Docket No. UM 1910

**BEFORE THE PUBLIC UTILITY COMMISSION
OF OREGON**

RENEWABLE NORTHWEST'S EXHIBIT 100

Opening Testimony of Michael O'Brien

Figure 1—RVOS Values by Element for PGE, PAC, and IPCo.¹²

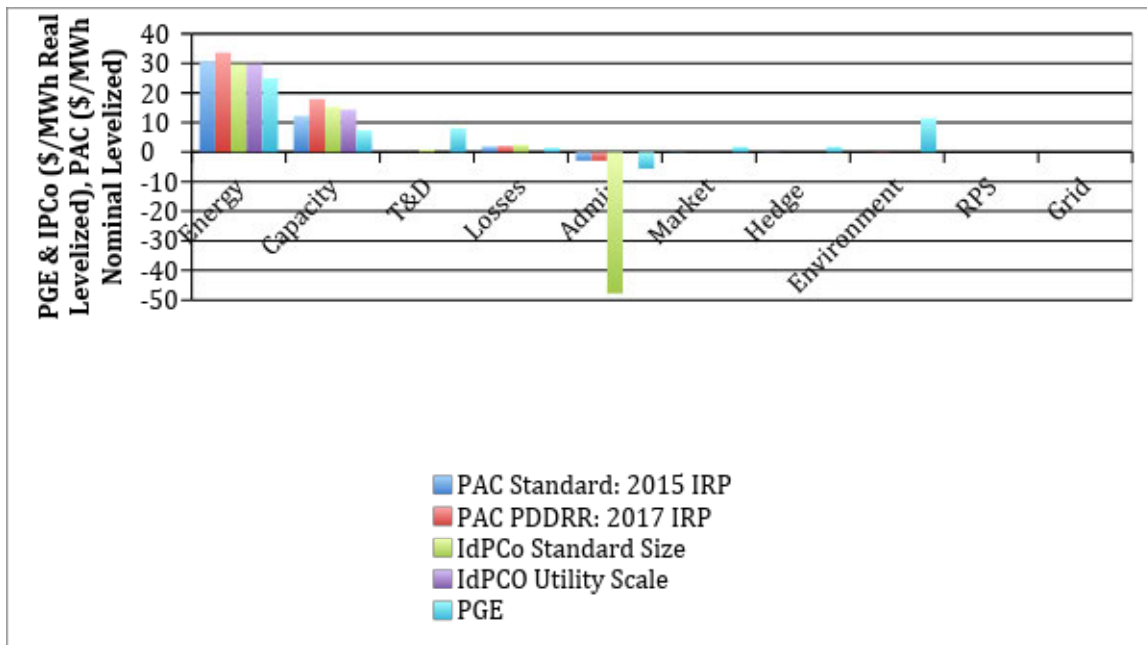
9 **Q. How do PacifiCorp’s RVOS values by element compare to Portland General**
 10 **Electric (“PGE”) (UM 1912) and Idaho Power (“IPCo”) (UM 1911)?**

11 A. Figure 1 shows the RVOS values by element for PGE, PacifiCorp and IPCo.

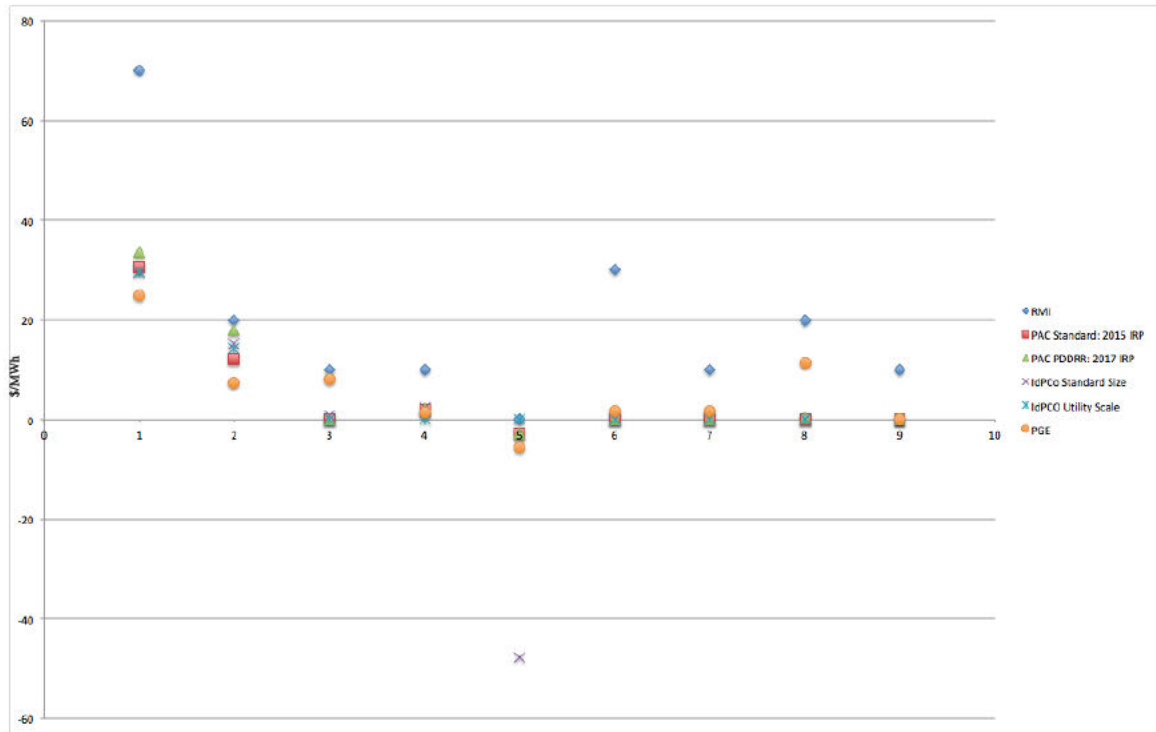
3 A. Yes. PacifiCorp bases its estimated RVOS on values for each element that appear
4 to generally be significantly lower than one would expect based on existing
5 research, resulting in what could be a depressed RVOS estimate. For example,
6 Figure 2 compares the values of each RVOS element used by PacifiCorp (as well
7 as Idaho Power Company and PGE) to the values of the same elements according
8 to a meta-analysis performed by the Rocky Mountain Institute in 2013.¹⁰³ As a
9 result, even where I have not noted specific disagreement with PacifiCorp's
10 methodology, I retain some skepticism and respectfully suggest that the
11 Commission take a hard look at PacifiCorp's proposal before approving a final
12 RVOS estimate.
